RANCH HILL SUBDIVISION, RESUBDIVISION OF

LOT 7

APPLICATION NUMBER 23 DATE October 16, 2003

RANCH HILLS SUBDIVISION, RESUBDIVISION OF LOT 7

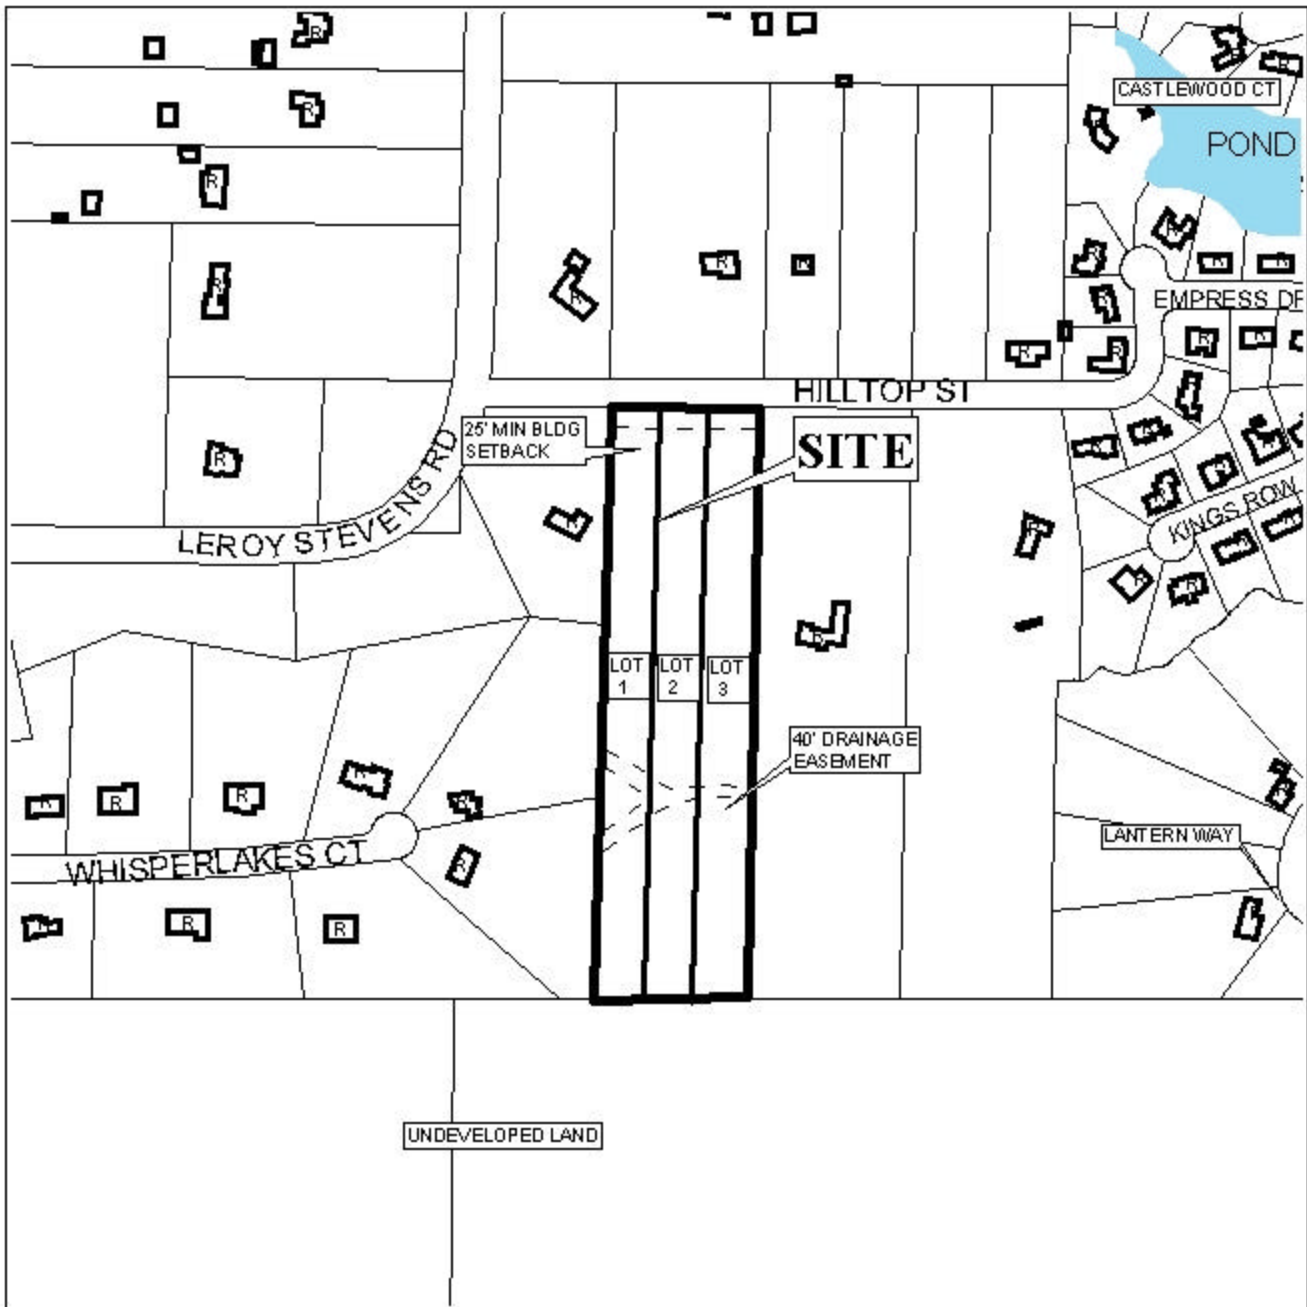
The lots are narrow, only 100' \pm in width, thus the placement of a note on the final plat stating that Lots 1, 2 and 3 are limited to one curb cut each to Hilltop Street, with the size, location and design to be approved by County Engineering, should be required.

As proposed, Lots 1, 2 and 3 would exceed the width to depth ratio, therefore a waiver of Section V.D.3. would be required. However, as proposed, the width of each lot is 107' and the depth is 1,253 feet. The Subdivision Regulations states that the maximum depth of a lot should not exceed 3.5 times the width of the lot. While this Section (V.D.3.) is often waived by the Commission, the lots are typically along waterways, or the proposed lots would be characteristic of the surrounding development. In this situation, the depth of the three lots would be 12 times the width, thereby exceeding the minimum standard by more than eight times. Additionally, none of the other parcels in the surrounding area are developed as such, making the proposed plat out of character with the area.

Based on the preceding, this application is recommended for denial for the following reason: 1) the width to depth ratio for the three lots far exceeds the minimum standard required by the Subdivision Regulations; and 2) the proposed plat is out of character with the surrounding development.
